2191 Hickory Grove Road  
 Land Lots 25 & 52-20th District  
 Cobb County, Georgia

**Rezoning Exhibit**

**PETITION NO:** Z-72

### Z-72            TRIFECTA HOLDINGS, LLC

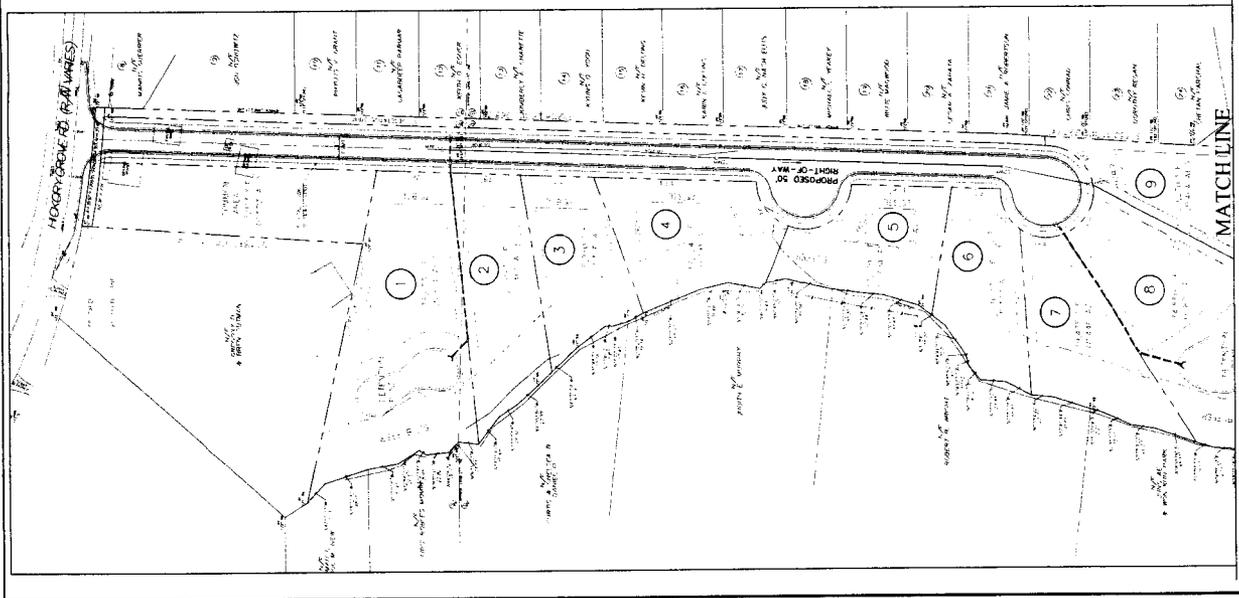
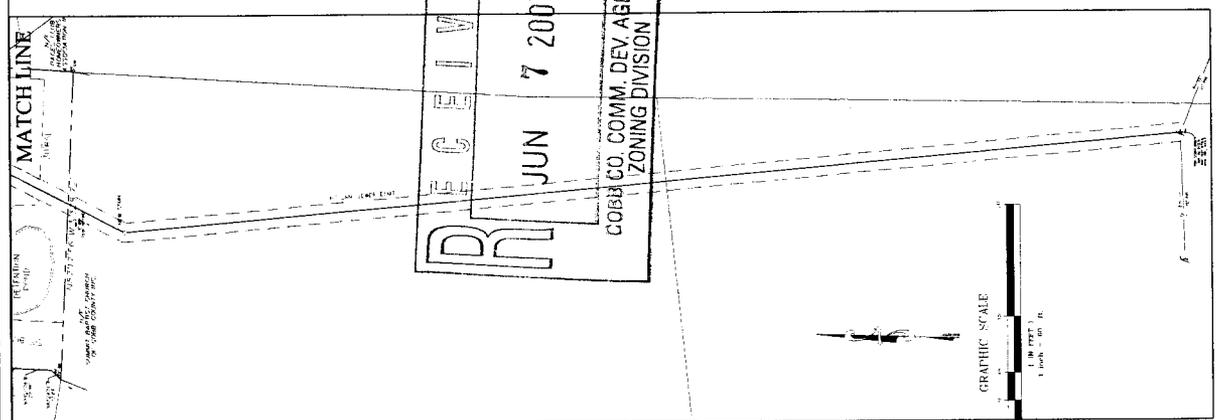
- No Stormwater controls shown \_\_\_\_\_
- Copy of survey is not current - Additional comments may be forthcoming when current site conditions are exposed.
- No site improvements showing on exhibit.

1. The proposed eyebrow cul-de-sac significantly impacts the buildable area of lots 4 and 5 as well as increases the impervious site area. This cul-de-sac should be eliminated if possible.
2. Two stormwater detention ponds are proposed. These ponds must be placed on separate lots with 20-foot flagged access to the public R/W. This will impact the layout for lots 1 and 8.
